Staff Report

Re: 27th Street Collective
Petition PLNSUB2019-00197 – Subdivision
Petition PLNSUB2019-00199 – Planned Development

SUBDIVISION & PLANNED DEVELOPMENT

PROPERTY ADDRESSES: Approximately 868 E. 2700 South & 2716 S. 900 East

27TH STREET COLLECTIVE
SUBDIVISION
LOCATED IN SW 1/4 OF SECTION 20, T1S, R1E, SLB&M
SALT LAKE CITY, UTAH

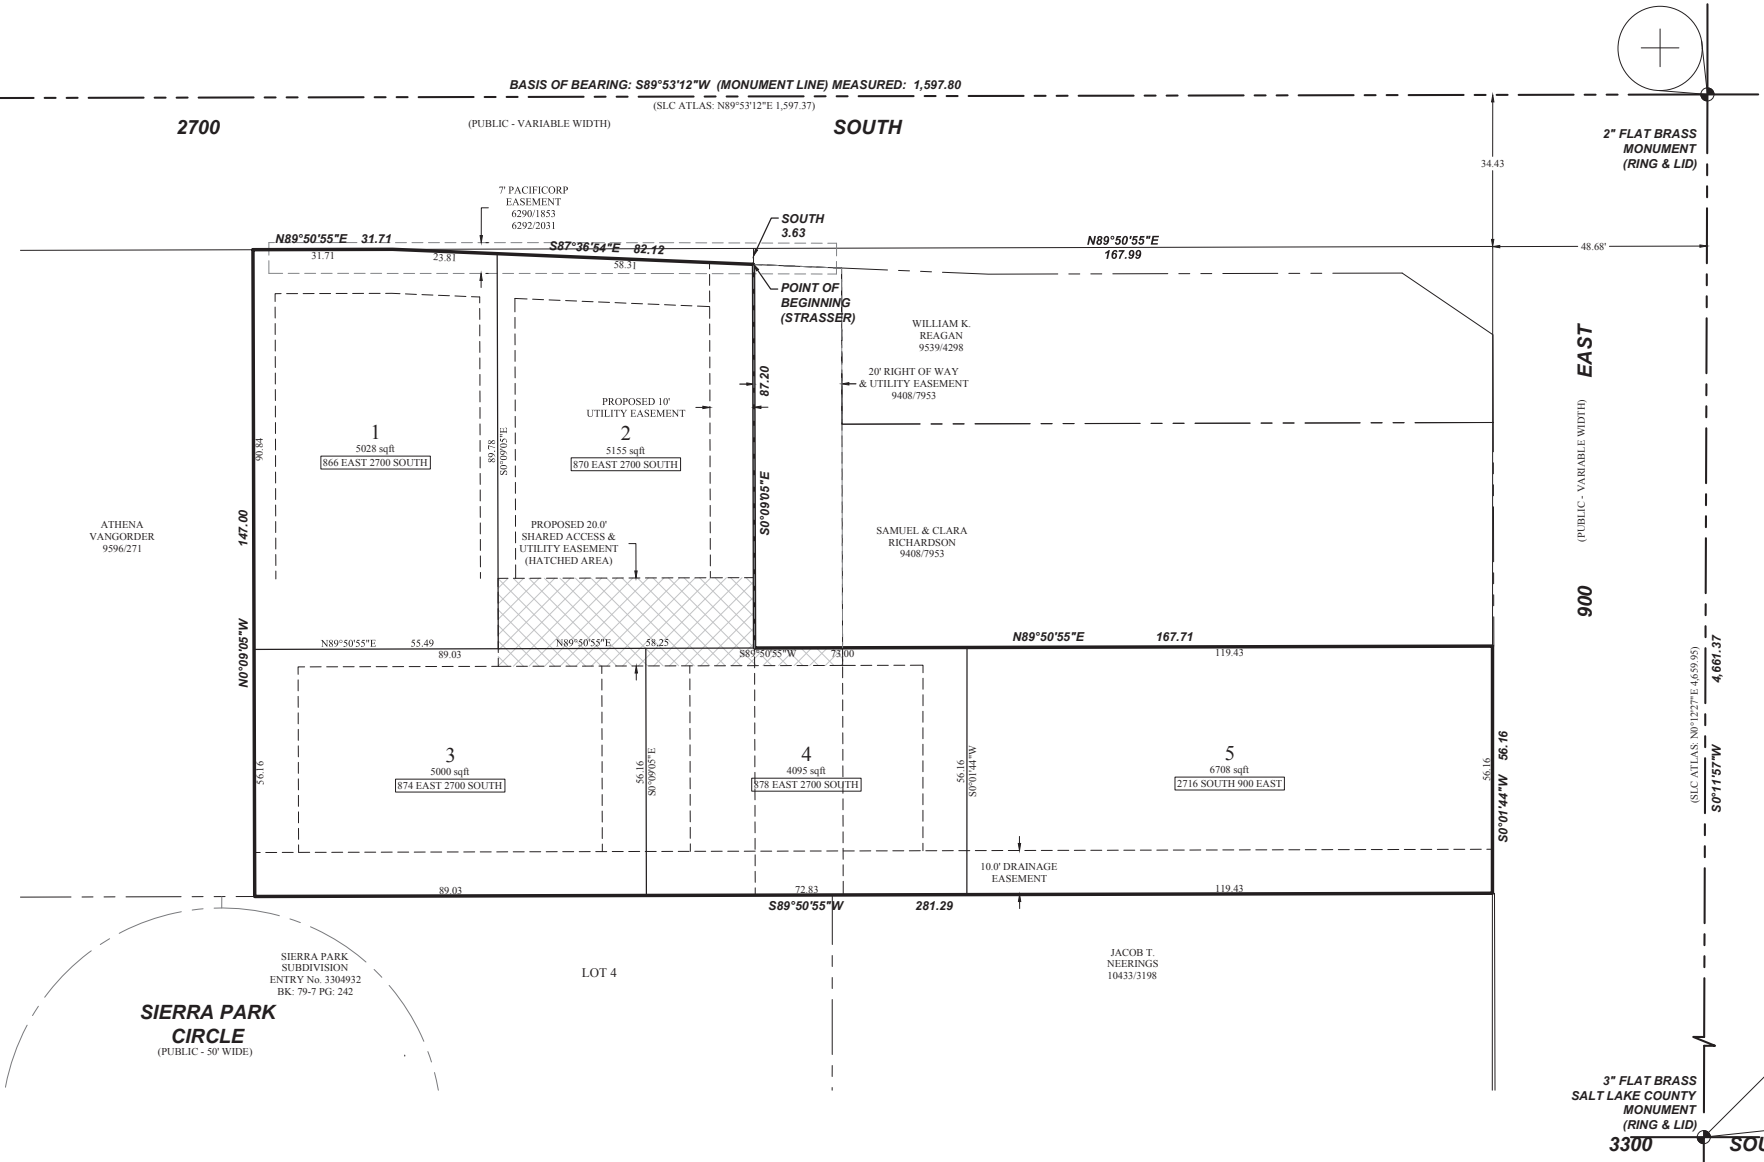
Another modification from requirements of zoning ordinance that appears to be requested is related by "Typical Building Setbacks" exhibit included upon the "27th Street Collective" plat sheet in which are depicted proposed setbacks that does not meet minimum required front setback that is normally required for development in the R-1/5000 (to be an average of principal buildings on the block face, normally); the other yard requirements will be satisfied;

The applicant should relate to purchasers, building permit reviewers and others any reduced yards that may be approved through planned development review/approval that information by depicting as platted yards upon the subdivision plat;

Portion of private property parcel to east of proposed subdivision, on "27th Street Collective" plat sheet, is labeled as "20' Right of Way and utility easement"; to propose how new lots may use 20 foot by 87.20 foot area as access to lots 2, 3 and 4 by either a) purchasing from neighboring lot (if, would not create any new non-compliance upon that property) and include in subdivision through lot line adjustment, and, enter into an access, maintenance, etc. agreement with that property so that that property (especially its existing carport) can continue to be accessed via that area or, b) to enter in access, maintenance, etc. agreements with that property to allow access across that portion of private property to the to-be-created parcels, or, c) provide access to lots of project within project and involve no other, adjacent properties; Requirements regarding designs of overall structure and interior side yard wall heights, foundation, attached garage location, front facade, and driveway, as well as building coverage limits, minimum required landscaping, private lands tree preservation, minimum required vehicle parking, accessory structures, etc. to be per zoning ordinance (specifically for R-1/5000 zone as well as general requirements found throughout zoning ordinance); payment of impact fees, use of certified address and other requirements to be per codes of the Salt Lake City, Utah City code (not necessarily per zoning portion of ordinances);
